SEWAGE DISPOSAL SYSTEM

MARYLAND STATE DEPARTMENT OF HEALTH

Robert Fansler IS PERMITTED TO INSTALL ALTER
ADDRESS 12132 Scaggsville Road, Fulton, Maryland 20759 PHONE 490-8284
SUBDIVISION Kings Manor ROAD 11905 Queen Street LOT 7
PROPERTY OWNER ~~Robert Fansler~~ Riley Lewis
ADDRESS same as above

PERMIT CARD

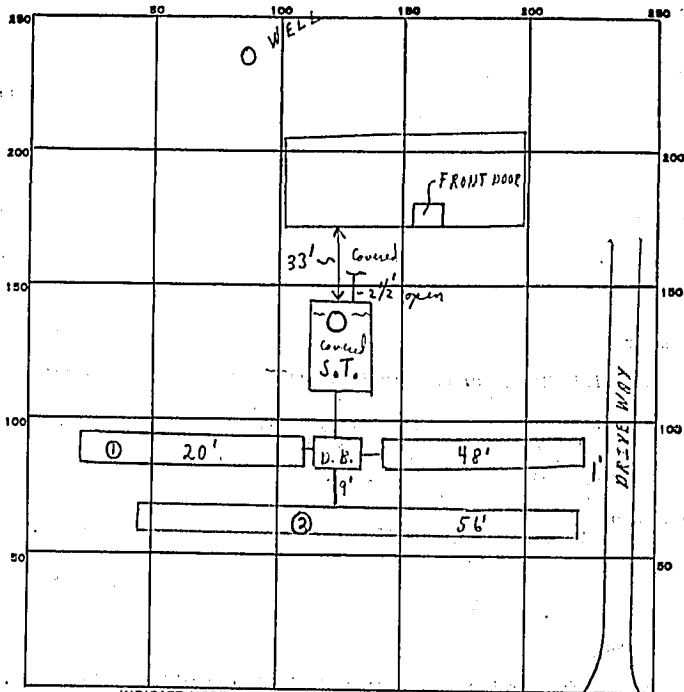
4/3/84 Top of manhole within 18" of surface. 5' of 8" plastic pipe extends above man hole cover. Block between man holes are O.K. to cover all trenches. Water tested OK *W.S.*

SEPTIC TANK, LEVEL CLEANOUTS S.T. NEED MAN-HOLE TYPE OK

DISTRIBUTION BOX, LEVEL NEEDS A BLOCK IN DIST. BOX - OK F.S.

REMARKS 3/27/84 checked all works - notes pipe covered from house to 2nd septic tanks; $\textcircled{1}$ pipes needs cement around areas of septic tanks as it comes from house; $\textcircled{2}$ ok for rest of stone in trench; $\textcircled{3}$ need water test on pipes from house to tanks; $\textcircled{4}$ need man hole types cover + cleanout at septic tanks; $\textcircled{5}$ need a considerable block in dist. box at 3' from pipes that connect from septic tanks; Partial c.o.s.d. 4/3/84
